LOT GRADING REVIEW

LECCO RIDGE DEVELOPMENTS INC.

LOT No. 262

PART OF LOT 6 CONCESSION 2, NEW SURVEY (GEOGRAPHIC TOWNSHIP OF TRAFALGAR) REGIONAL MUNICIPALITY OF HALTON 20M-1184 TOWN OF MILTON

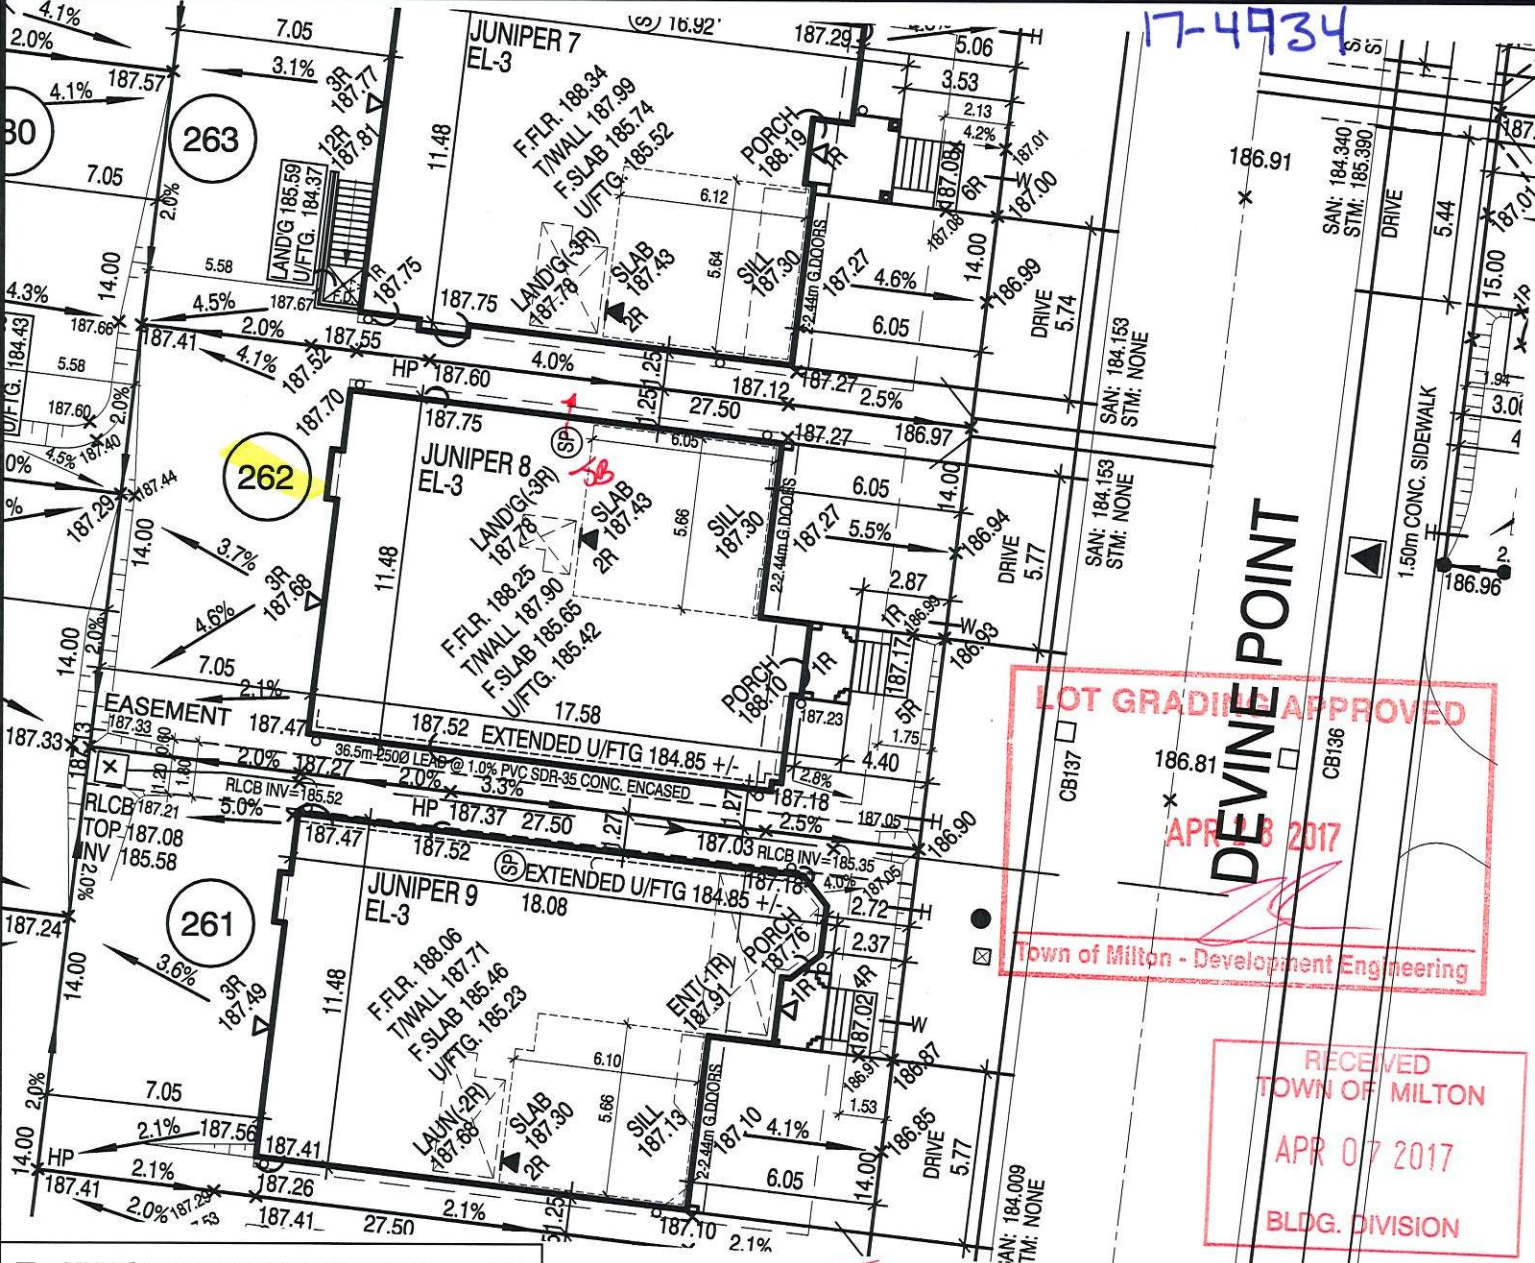
45 Min FRR

45 Min FRR w/NC Cladding

Guard/Handrail as per 9.8.

2.1 m Backfill height as per 9.15.

Siting to be read in conjunction with reviewed main model drawings

SUMP PUMP TO DISCHARGE TO REAR SPLASH PAD.

45 MINUTE RATED WALL WITH SIDE YARD < 1.2m
